Addendum No. 1
To
REQUEST FOR BIDS
For
Belton Intake Project 2026

Scope of Work Section 4 Item C- Chemical Injection Line Management

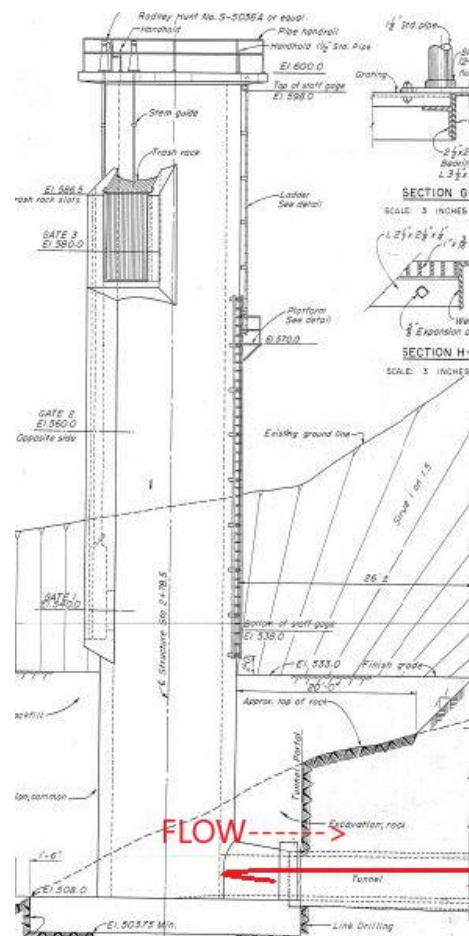
- Survey routing of 1 in black polyethylene line in tunnel.
- Re-route/secure line with standoffs and clamps to at the 3 o'clock position. Stainless hardware clamps may be used in addition to concrete anchors. Spacing every 20ft. This will roughly come out to 10-12 clamps. **Fig 1.** show the layout of our last clamp setup. **Fig 2.** Shows how the 1-inch black poly line is to be terminated with no kinks in line. A long sweep with an open end going with the flow of raw water. **Fig 3** shows a better close up of the long sweep. The three black marks resemble clamps.
